HISTORIC AND DESIGN REVIEW COMMISSION

HDRC CASE NO: 2019-302
ADDRESS: 131 ADAMS ST
LEGAL DESCRIPTION: NCB 931 BLK 1 LOT 15
ZONING: RM-4, H
CITY COUNCIL DIST.: 1
DISTRICT: King William Historic District
APPLICANT: Daniel Sexton /Buffalo Contracting
OWNER: Beverley Bunn/BEAVER MEADOWS II LLC
TYPE OF WORK: Front door replacement
APPLICATION RECEIVED: May 14, 2019
60-DAY REVIEW: July 13, 2019
CASE MANAGER: Huy Pham
REQUEST:

The applicant is requesting a Certificate of Appropriateness for approval to replace the existing, wood fan lite door with a wood door featuring ornamental rectangular lites and a metal kick plate.

PROPOSED DOOR, INSTALLED PRIOR TO APPROVAL

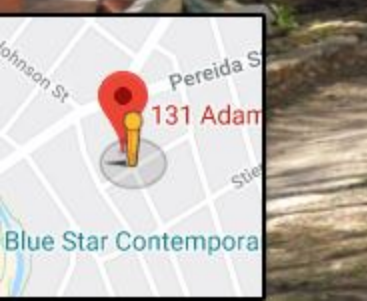
- b. **COMPLIANCE** – On a site visit on May 9, 2019, staff found that the front door had been replaced prior to approval. The applicant was cooperative to submit an application to be heard at the next available HDRC hearing.

- c. **DOOR REPLACEMENT** – The applicant has proposed to replace the existing, wood fan lite door with a wood door featuring ornamental rectangular lites and a metal kick plate. Per the Guidelines for Exterior Maintenance and Alterations 6.B.i., doors should be replaced in-kind when possible and when deteriorated beyond repair. When in-kind replacement is not feasible, ensure features match the size, material, and profile to the historic element. Staff finds that the existing door is not original to the structure and may be replaced with an appropriate style door. The proposed door is a departure from the American Foursquare/Craftsman style of the structure.

Staff recommends approval of door replacement based on finding c with the stipulation that a door style that is appropriate to the American Foursquare/Craftsman style is submitted to staff for verification.
